NOTICE OF NON-PERFORMANCE

On February 25, 2026, Energy Safety conducted an inspection of Southern California Edison Company's WMP initiatives in the vicinity of the city of Temecula, California. The inspection report is enclosed herewith. Energy Safety found the following deficiencies:

INSPECTION REPORT

Glm3: Transformer bushing cover is open.

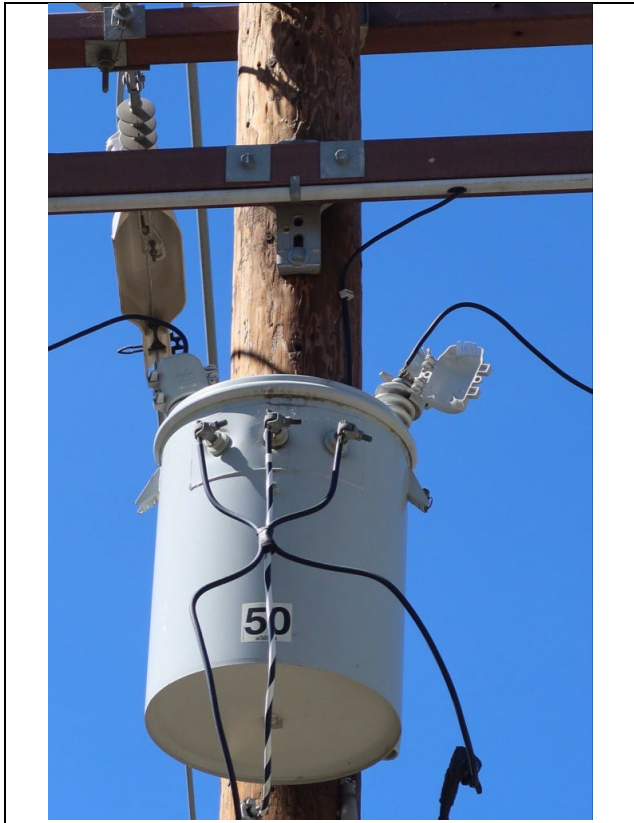
On Pole ID 2091164E, Grid Hardening ID 414478355-2091164E at 27070 Avenida del Oro, Temecula, CA, 92590, USA, 33.4996301120858, -117.194118064684, the inspector observed that the transformer bushing cover was open. The inspector's observation is documented in Deficiency 1 photographs, which are attachments to this report. Photo numbers G1mg1, G1mg2, and G1mg3 depict an open transformer bushing cover.

1. Southern California Edison Company's work on 2025 WMP initiative number 8.1.3.1, Distribution Detailed Inspections and Remediations, identified that the remediation of missing transformer bushing caps was completed at the location.
2. The transformer bushing cover was left open.
3. SCE Distribution Construction Standard DC-535 states that "wildlife-safe power line construction standards are intended to protect lines from wildlife and vice versa by constructing sufficient phase-to-phase and phase-to-ground clearances as well as installing approved protective materials on high voltages lines and equipment. In addition, installing wildlife covers in the correct application will mitigate other contact-related faults from foreign materials."⁸

Deficiency 1. Energy Safety observed that in implementing 2025 WMP initiative 8.1.3.1 - Distribution High Fire Risk-Informed (HFRI) Inspections and Remediations (IN-1.1), SCE failed to complete the remediation of missing transformer bushing caps on Pole ID 2091164E, Grid Hardening ID 414478355-2091164E at coordinates 33.4996301120858, -117.194118064684. Energy Safety considers this non-performance to be in the Minor risk category. SCE must complete corrective action for this deficiency within 12 months from the date of the notice.¹
